Service Bulletin EA-300 Engine fuel pump vent

No. 300-1-05

Subject: Engine fuel pump vent

Affected Aircraft: EA-300 S/N V1, 1 through 67

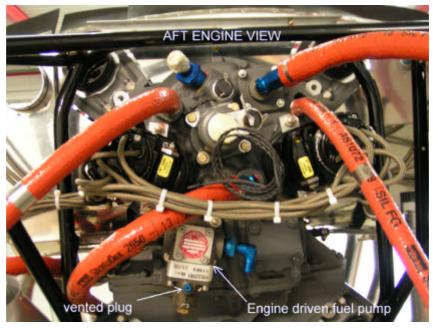
1. Inspect whether correct fitting is installed through opening in lower cowling. It may be necessary to remove the cowling. The engine driven fuel pump is located on the aft side of the engine just below the magnetos. The vented plug is positioned at the valve cover on the lower part of the pump and points aft. The fitting must have a vent hole though its axis. If the vent hole is present, no further action is needed.

- 2. If a plug without vent hole is installed, it must be removed and replaced by a vented plug Lear Romec P/N RA9087 or a modified MS20913-1D.
- 3. To modify a standard MS20913-1D (formally AN913-1D) drill an axial hole of 2 mm (1/16 inch) through the fitting.
- 4. Re-install removed cowling.
- 5. Fill out Appendix of this SB and send to
